APPLICATION NO.	FILING DATE	FIRST NAMED INVENTOR	ATTORNEY DOCKET NO.	CONFIRMATION NO.
10/773,275	02/09/2004	Franz Sieberer	2004-0129A	8571

<p align="center"><b>Advisory Action</b> <b>Before the Filing of an Appeal Brief</b></p>	Application No. 10/773.275	Applicant(s) SIEBERER, FRANZ	
	Examiner Ernesto Garcia	Art Unit 3679

Continuation of 13. Other: The drawings filed on 12/23/05 are not acceptable. Figures 8b and 11b show the spring 12 embedded in the pin 6. The use of solid black lines to show cross hatching in Figure 11c is not permitted. The ends of the broken lines in Figures 2a, 2b, 3a, 3b, 4b, 6a, 6b, 7a, 7b, 8a, 8b, 9a, 9b, 10a, 10b, 11a, and 11b should be designated by Arabic or Roman numerals corresponding to the view number of the sectional view. See 37 CFR 1.84(h)(3) and MPEP 608.02(e). Note that the broken line in Figure 2a should be 2b and not 1 as there is no Figure 1 showing view number 1-1. Further, the legend A-A, B-B, etc. in the views should be deleted. Further, what is going on with the pin 4 in Figures 3b and 3c? Is the pin bisecting the hook 10?

Fig. 4b

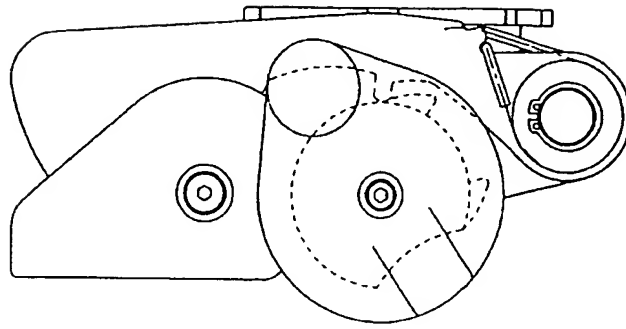
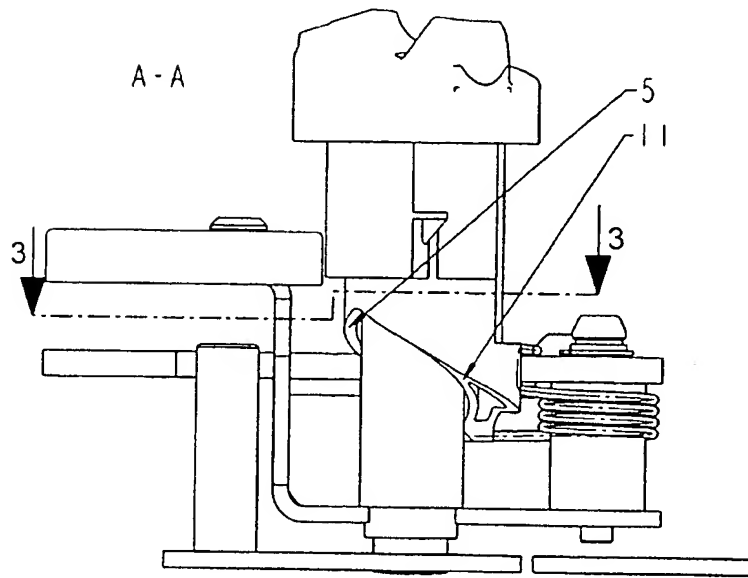
Continuation of 11. does NOT place the application in condition for allowance because: applicants have argued that the functional limitations in claim 1 add structural limitations without identifying what structure corresponds to the functional limitations. Applicants argued that the locking device and the securing hook must be constructed and structurally arranged such that these components perform the functional limitations recited. In response, the limitation "constructed and structurally arranged" does not add any structure since construction and arrangement does not add any more structure than what is present. The mere fact that the locking device and the securing hook is present in the reference EP-694460 is an indication that it has been constructed. Further, the mere fact that the locking device and the securing hook are next to each is evidence that these two components are structurally arranged next to each other. Given these components, their cooperation inherently allows operation to act on a side extension of a vehicle. Applicants further argued that '460 reference teach the beam is not locked in the locked position. In response, this argument is irrelevant as the claims do not positively call for a beam and any argument made reference to the beam does not add weight when such is not claimed. Applicants further argued that the release of the hook does not leads to a release of the hook from an anchorage position, but instead moves the hook to an anchorage position. This argument is not persuasive. Applicants have not clearly analyzed the actions between Figure 3c and Figure 3b. The figures clearly teach the release of the locking device 11 releases the hook from an anchorage position otherwise the hook would not move to the position shown in Figure 3a. It is clear that Figure 3a shows the hook 10 in a release position as compared to a non-released position shown in Figure 3c. Again, any reference to the beam is irrelevant as no beam is claimed. In respect to claim 6, the examiner has taken its broadest reasonable interpretation of "independent of a direction of rotation of the locking device". Applicants should note that rotating the locking device does not dependently move the hook in the same fashion gears move. In respect to claim 8, the argument is persuasive. The spring 8 does not urge the detent member 11 to a locking position, but rather urges the claw 4 to a locked position. Therefore, the examiner is withdrawing the rejection and objecting the claim as being dependent upon a rejected base claim. In respect to Murphy, the same responses to claim 1 above apply. Further, applicants argued that Murphy does not disclose the release of the cam arrangement 15 leads to a release of the locking member. In response, applicants should note that the examiner has given the broadest reasonable interpretation. It is clear that releasing the locking device 15 leads to a release of the locking member (see Figure 4).
